Value Engineering Study
I-64 WESTBOUND TO I-264
WESTBOUND RAMP IMPROVEMENTS
JEFFERSON COUNTY, KENTUCKY

ITEM NUMBER 5-159.00
VE STUDY NUMBER 201203

Final Report

URS conducted a Value Engineering (VE) study of the I-64 westbound to I-264 westbound ramp improvements in Jefferson County, Kentucky. The Item Number is 5-159.00. The topic was the 30% design submission prepared by Parsons Brinckerhoff for the Kentucky Transportation Cabinet (KYTC).

Current Signs on I-64

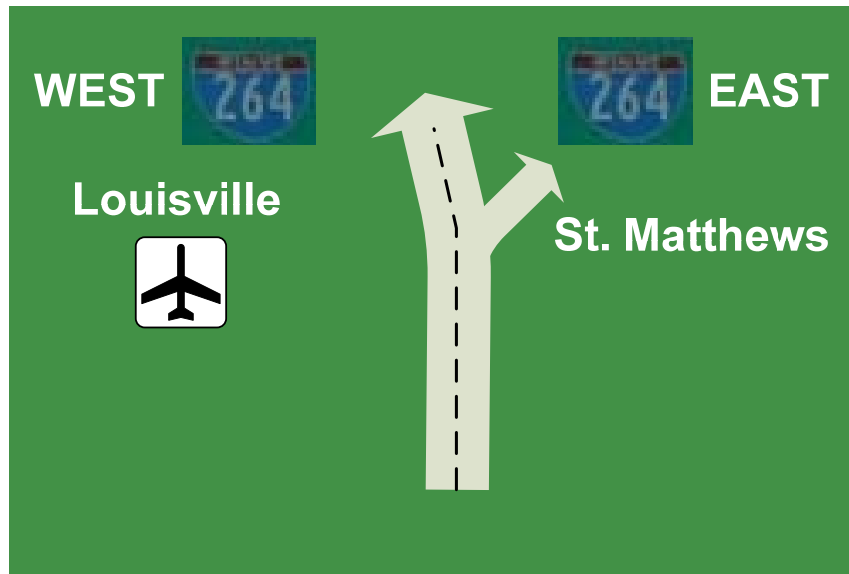
First, the current signage does not indicate which lane a driver must occupy to travel either west or east on I-264.

The VE Team recommends that some of the signing be redesigned. The first recommendation is to use a diagrammatic sign after the gore area of the exit so drivers know which lanes are allowed. This will mean moving the existing truss that currently is located past the gore of the split of the I-264 ramps 500 ft to the east.

Looking West at the Existing Browns Lane Structure

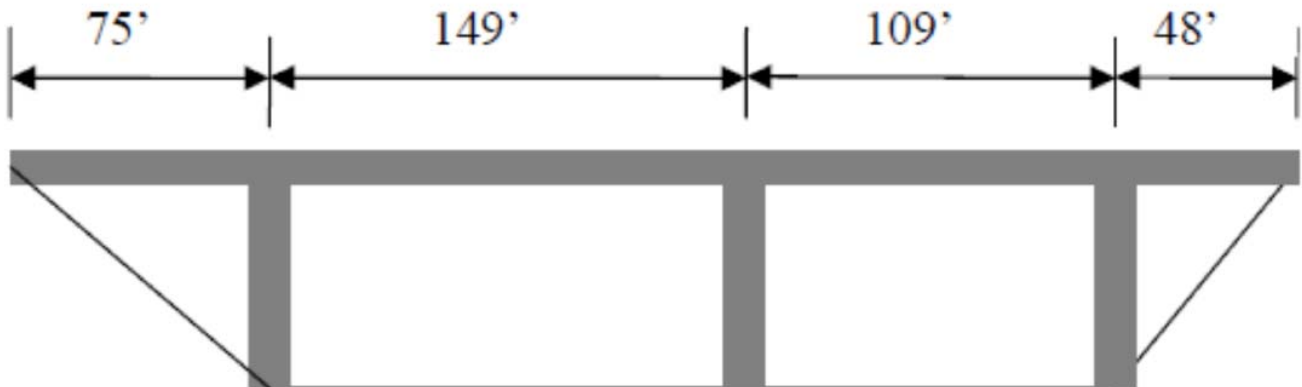
The original design describes reconstructing a portion of the 4-span bridge to accommodate the I-264 interstate widening. This reconstruction would include construction of a new pier, abutment, and superstructure on the north side of I-264. The span length arrangement of the original design is 75 ft-149 ft-135 ft-51 ft.

The VE Team recommends relocating Pier 3 and maintaining the existing continuous steel girders and concrete slab. The revised span length would be approximately 75 ft-149 ft-120 ft-37 ft (total length of 381 ft is unchanged). The VE Team recommends utilizing a MSE wall to support the embankment, which is being removed as part of the original design for construction of the roadway widening.

SKETCH OF ORIGINAL AND RECOMMENDED DESIGN

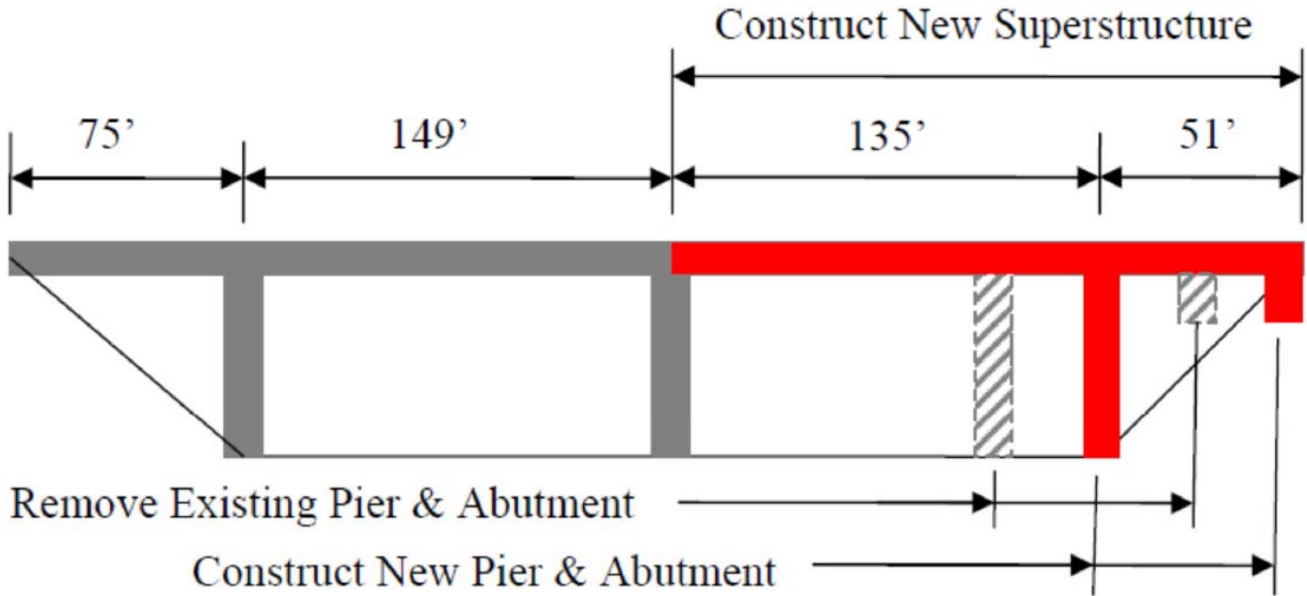
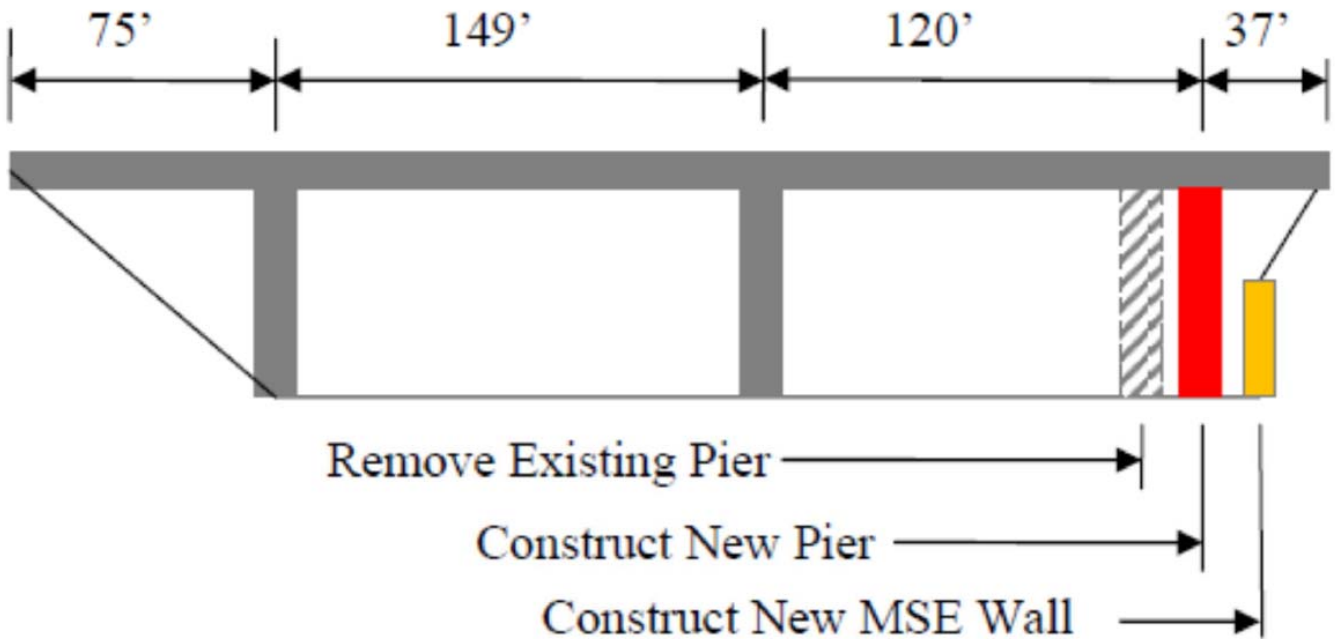
- Potential uplift at abutment
- Piling options limited
- Original piers must be checked to whether they can withstand new loads based on span length changes

SKETCH OF LOCATION MAP

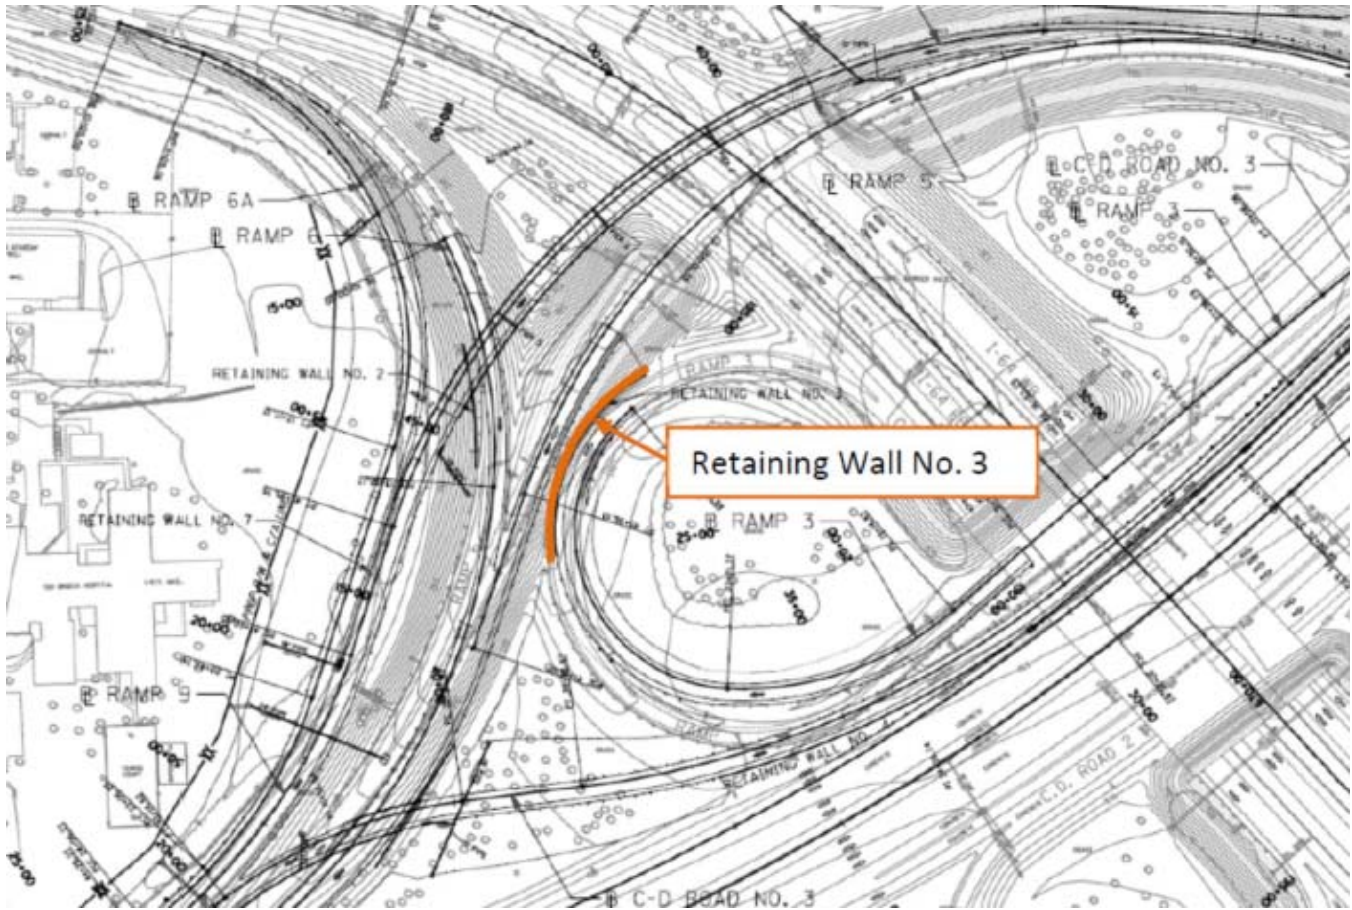
The original design specifies that Retaining Wall Number 3 adjacent to Ramp 3 be removed and replaced.

The VE Team recommends that this wall remain in service by either allowing slopes steeper than 2:1 or by extending the height of the wall.

SKETCH OF RECOMMENDED DESIGN

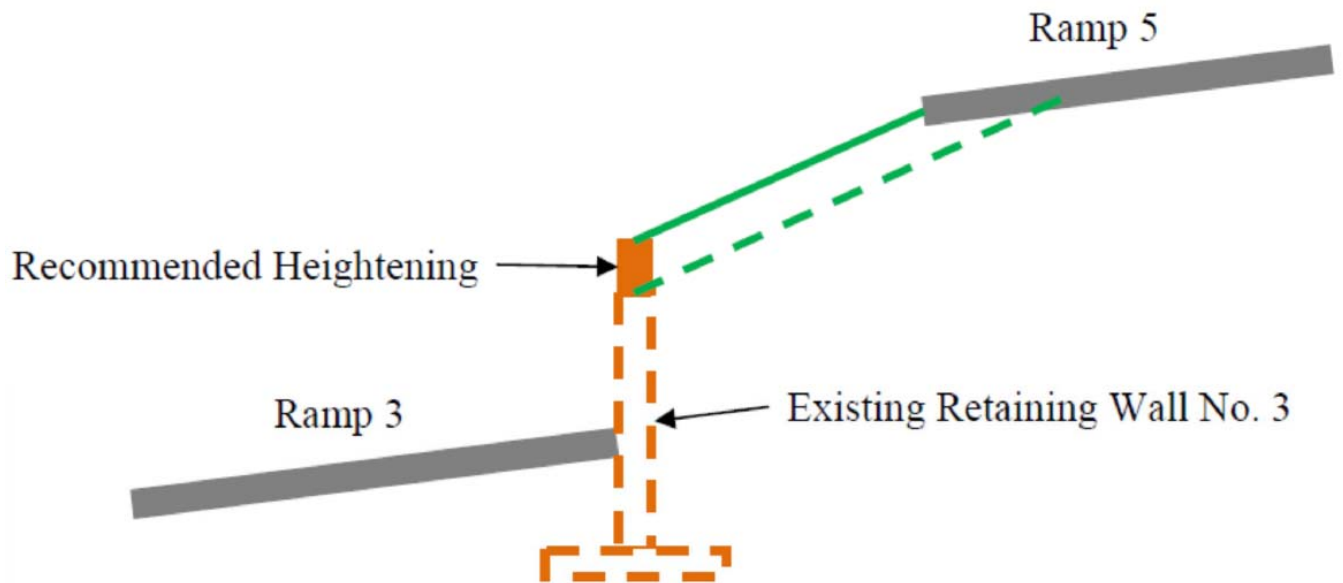
The additional embankment necessary to construct Ramp 5 does not exceed any higher than two feet above the existing embankment in the vicinity of the retaining wall. If the geotechnical recommendations allows, the slope could be steeper to utilize the existing wall without modification. If steeper slopes are not feasible, a structural analysis will likely indicate the existing retaining wall can be heightened to accommodate the additional embankment. It is not anticipated that this will overstress the existing wall or foundation since the typical drawings for these walls also allow an optional top mounted barrier wall; and therefore, the walls likely have excess capacity as they should have been designed to also resist impact loads (this existing retaining wall does not have a top mounted barrier).

Reduced Shoulders to Fit Roadway within Existing Piers

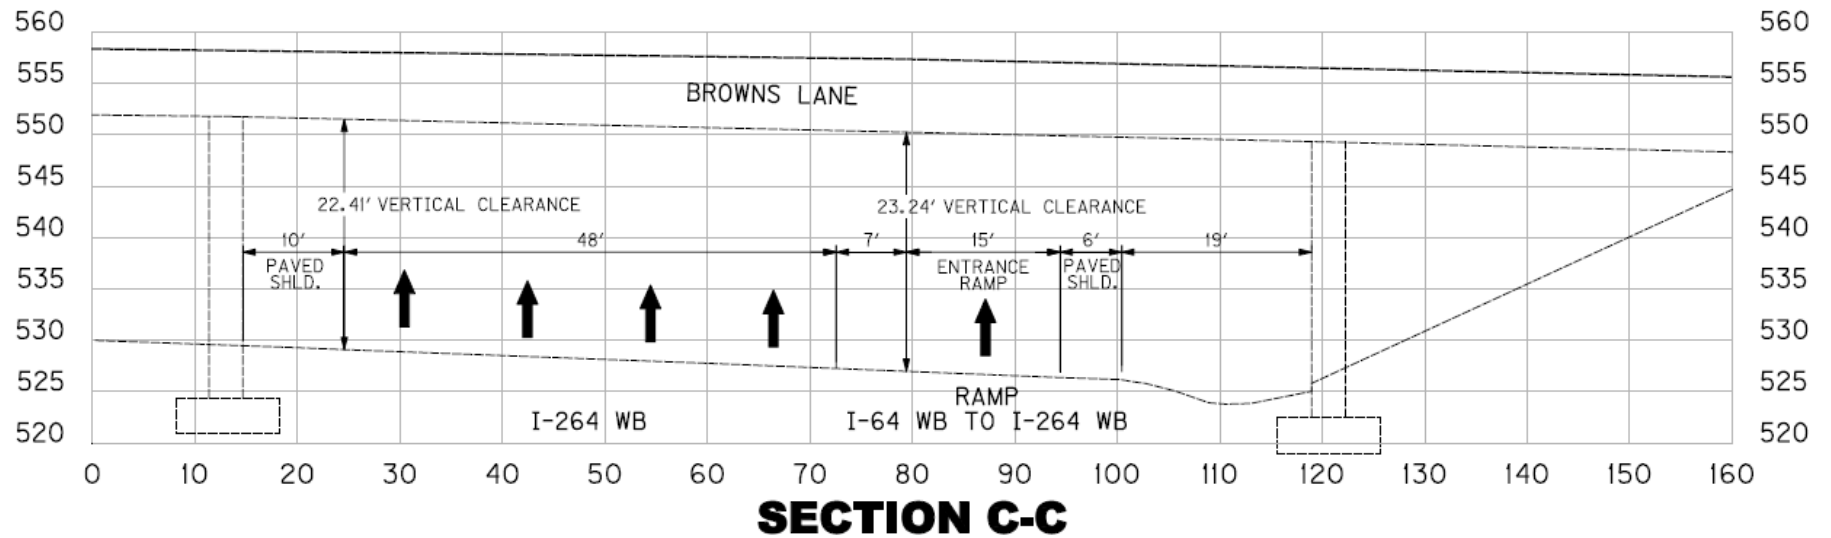
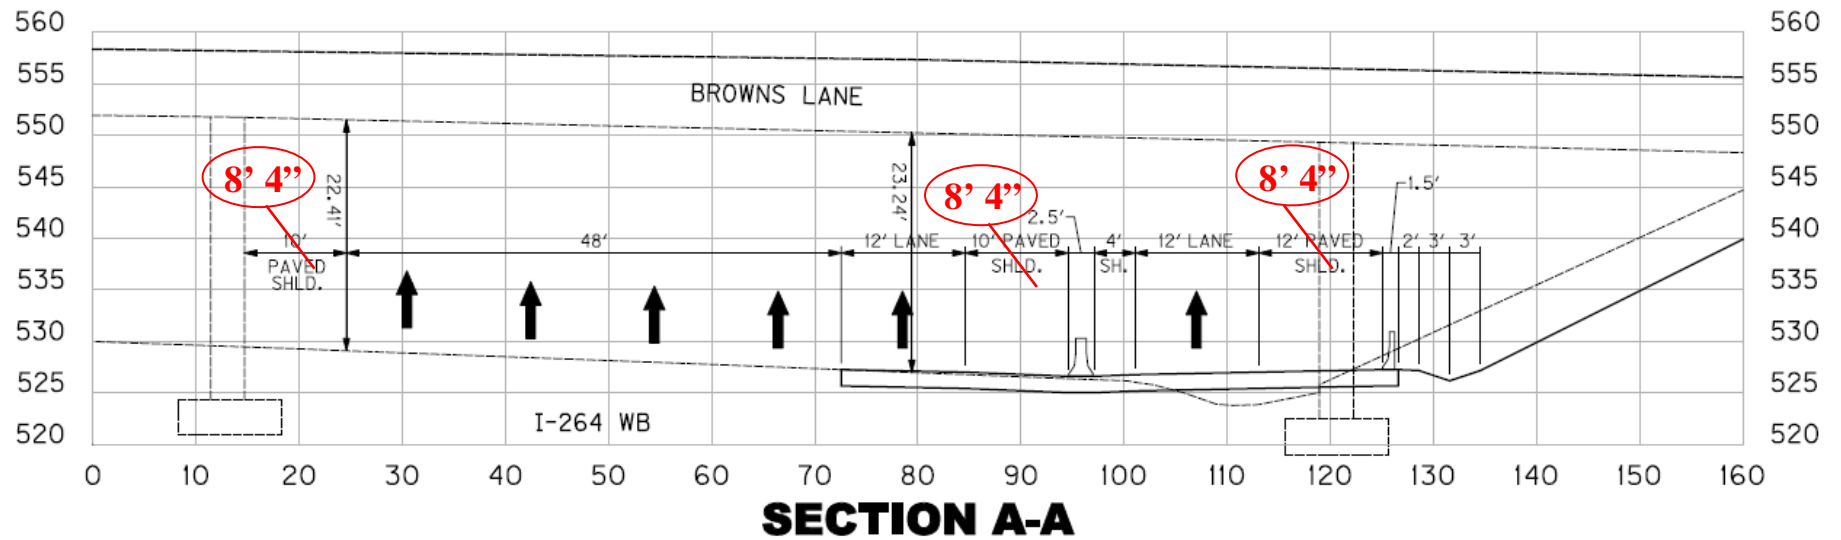
The recommendation provides for the same design intent but with less shoulder area which will require a design exception. However, the change still provides space for emergency vehicles while keeping the full width travel lanes. The change will lessen the impacts to the adjoining property owners and the high potential for condemnation in this business area especially with the owner of the storage units.

Fitting the typical section between the piers will not require reconstructing the Browns Lane structure. This eliminates the impacts to the traveling public on the Brown Lane structure which is a major route to the hospitals and residential neighborhoods. The reduced typical will change the location of the pavement strip which may not coincide with the existing longitude concrete joints; however, since this is in a tangent section, this does not appear to be a significant issue.

SKETCH OF RECOMMENDED DESIGN

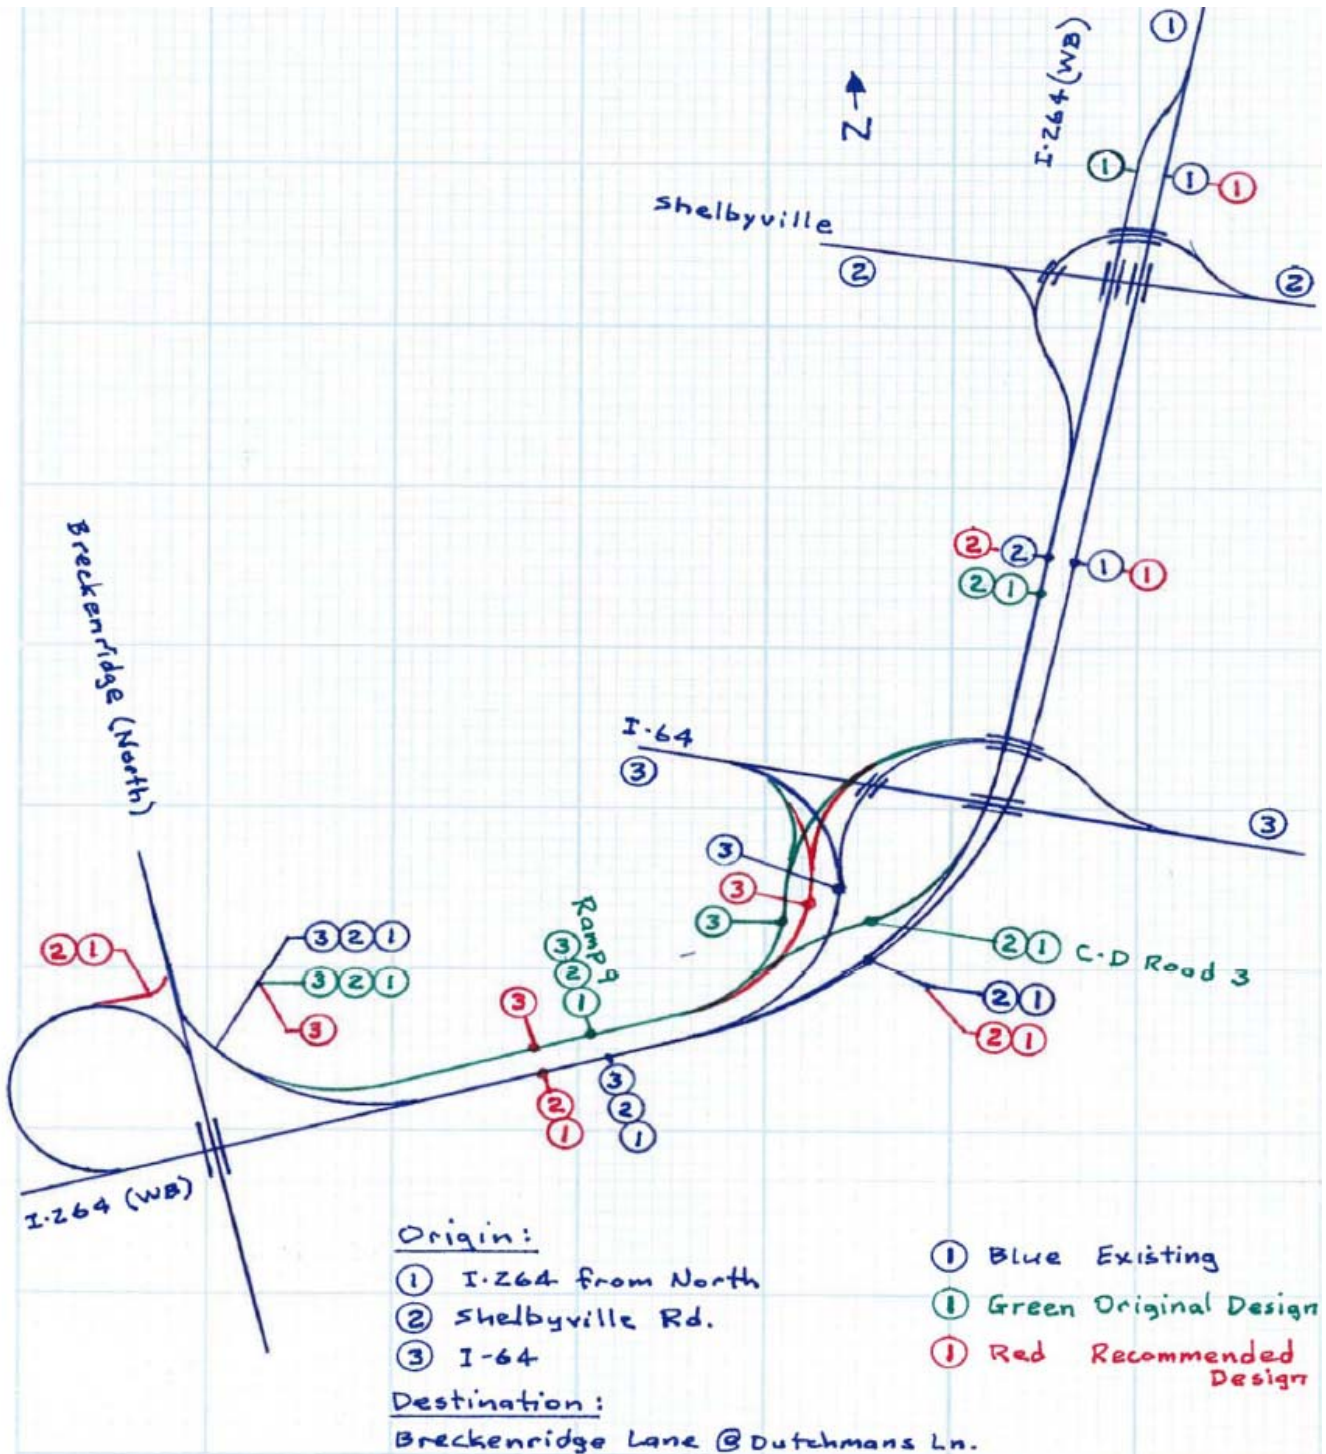
Eliminate C-D Road 3 and the braided interchange and force westbound I-264 mainline traffic to exit at a modified partial cloverleaf interchange at Breckenridge Lane.

C-D Road 1 would begin with four lanes east of I-64. One lane each would drop to I-64 WB and to I-64 EB. The two remaining lanes would merge into one, prior to joining I-264 WB (three lanes total). Traffic from I-264 WB and Shelbyville Road would use I-264 WB to get to Breckenridge Lane NB via modification to the existing loop ramp ("Exit 18A"), then, traffic would turn left onto Breckenridge Lane NB. Traffic coming from both directions of I-64 and exiting at Breckenridge Lane would use Original Design Ramp 9.

- Significantly reduces bridges and embankment
- Significantly reduces utility relocation
- Simpler to understand and meets normal driver expectations
- Does not require ROW along C-D Road No. 1 to Breckenridge Lane
- Significant cost savings realized for rerouting one minor exit movement to Breckenridge Lane
- Does not require Ramp 3 modification
- Does not require moving Browns Lane pier
